Change Order

Hardin County Early College & Career
Center
University Drive
Elizabethtown, Kentucky

CHANGE ORDER NUMBER: 008**DATE:** December 16, 2014**TO CONTRACTOR (Name and address):**

REQUEST FOR CHANGE ORDER

A PARTIAL LOWER LEVEL PLAN - AREA "A" - MECHANICAL

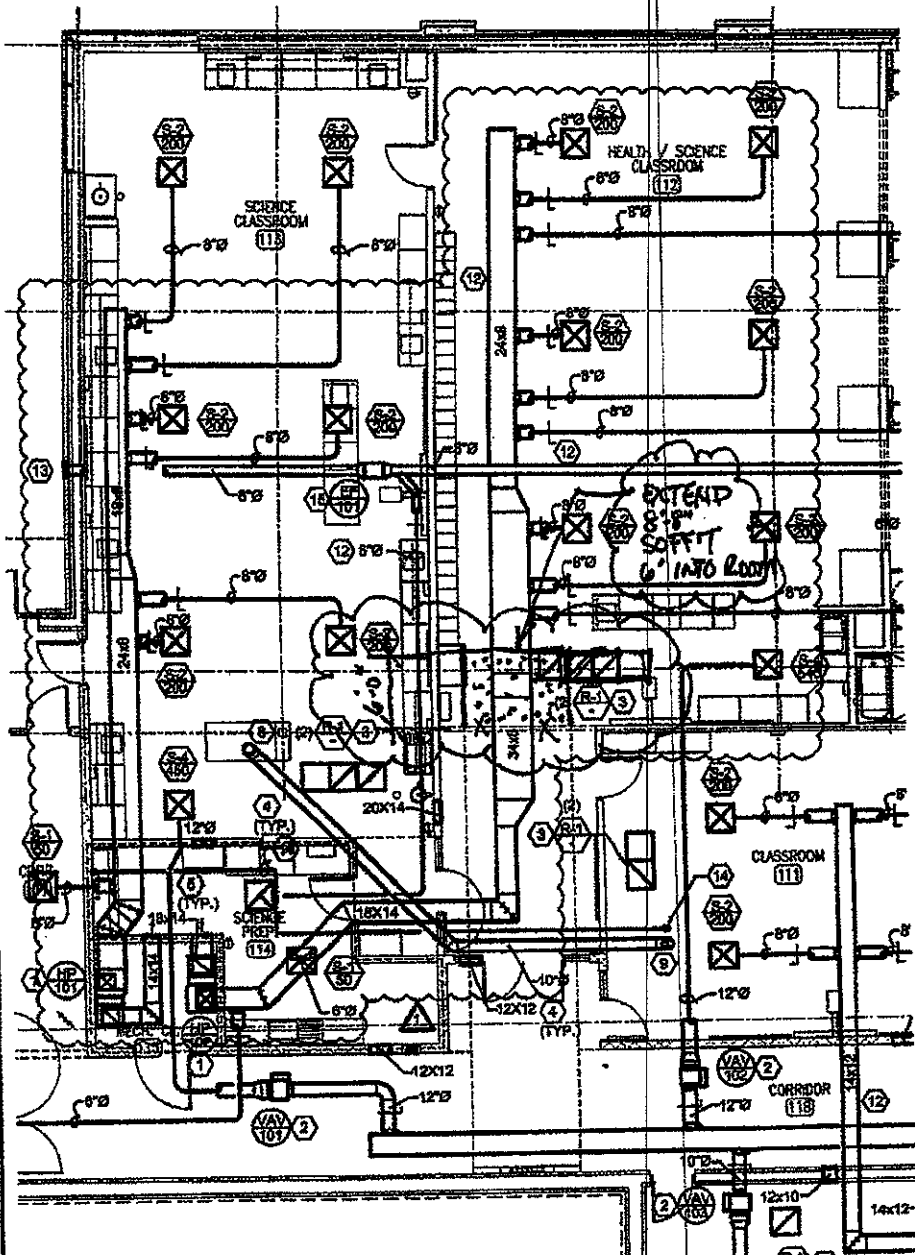
Extend soffit 6 foot into classroom 112 and add bulkhead soffit at Classroom 138, per: Sherman Carter Barnhart sketches received March 3, 2014

RE: Hardin County Early College and Career Center
Elizabethtown, KY
Duct Revisions Classroom 112 and 138

See attached for the drawings showing the duct changes discussed in last weeks meeting. I thought I sent it Tuesday but it never went through.

P1.3A PARTIAL UPPER LEVEL PLAN - AREA 'A' - PLUMBING - WATER & GAS

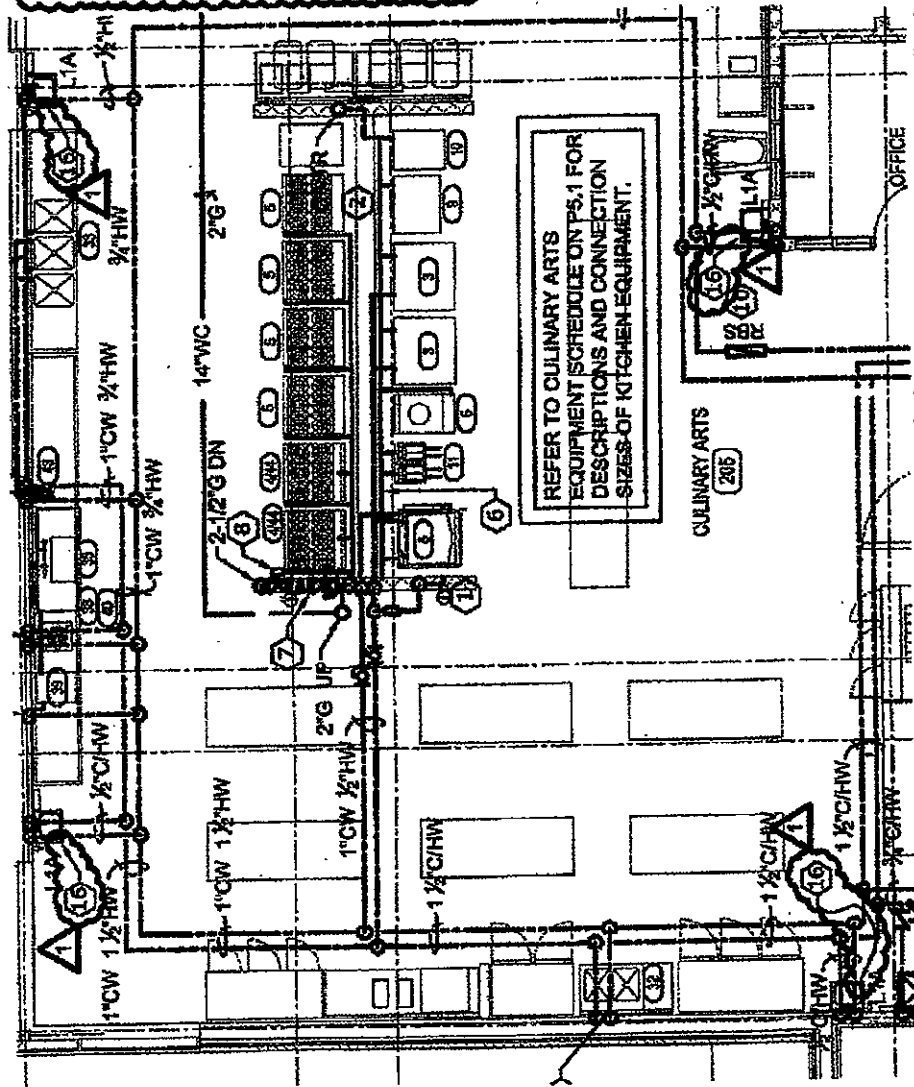
Provide cost proposal for changes to the lavatories in the Culinary area as shown on the attached drawing.

- CHANGE FAUCET TO T&S BRASS B-0882 FAUCET WITH 4" CENTERS, GOOSENECK FAUCET AND WRIST BLADE HANDLES. RE-ROUTE SUPPLIES TO T & S BRASS 0804-SL DOUBLE PEDAL VALVE WITH SLOW CLOSING METERING CARTRIDGES, ADJUSTABLE HEIGHT PEDALS WITH FOLD UP OPTION. ROUTE OUTLET TO BOTH HOT AND COLD CONNECTIONS ON NEW FAUCET. INSTALL PER MANUFACTURERS INSTRUCTIONS. REWORK ROUGH-IN AS NECESSARY FOR FAUCET REPLACEMENT.

P3.1E PARTIAL MANUFACTURING & INDUSTRIAL PLAN - PROCESS PIPING

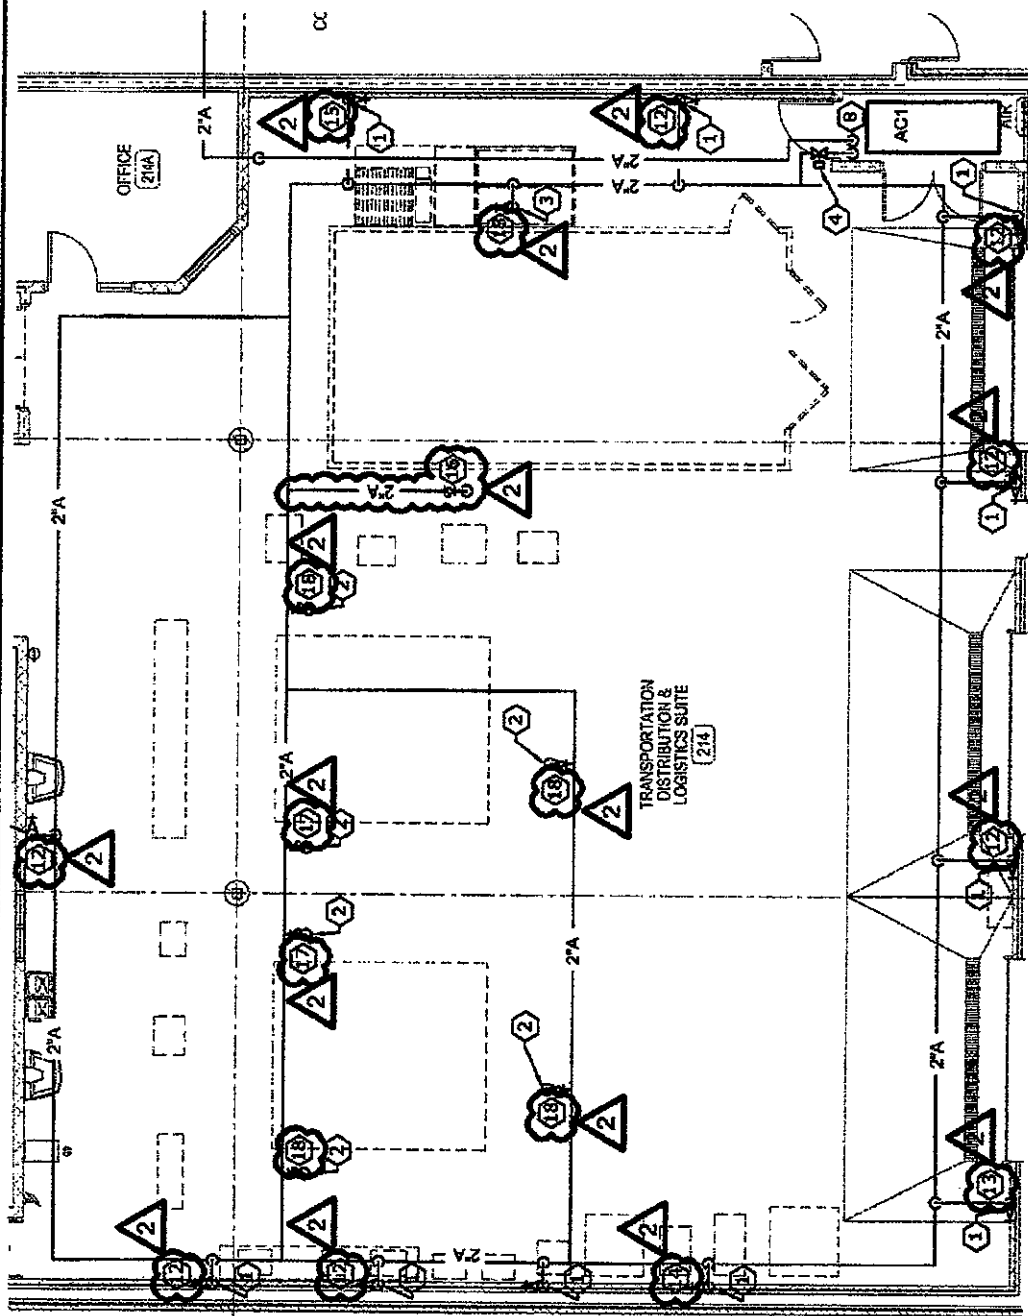
Contractor shall provide a cost proposal for fit-up of the shop areas as shown on the attached drawings.

PROVIDE AND SUPPLY ALL NECESSARY FITTING, BRACKETS, HANGERS, HOSES, ADAPTERS, SUPPORTS, VALVES AND OTHER ACCESSORIES REQUIRED FOR INSTALLATION.
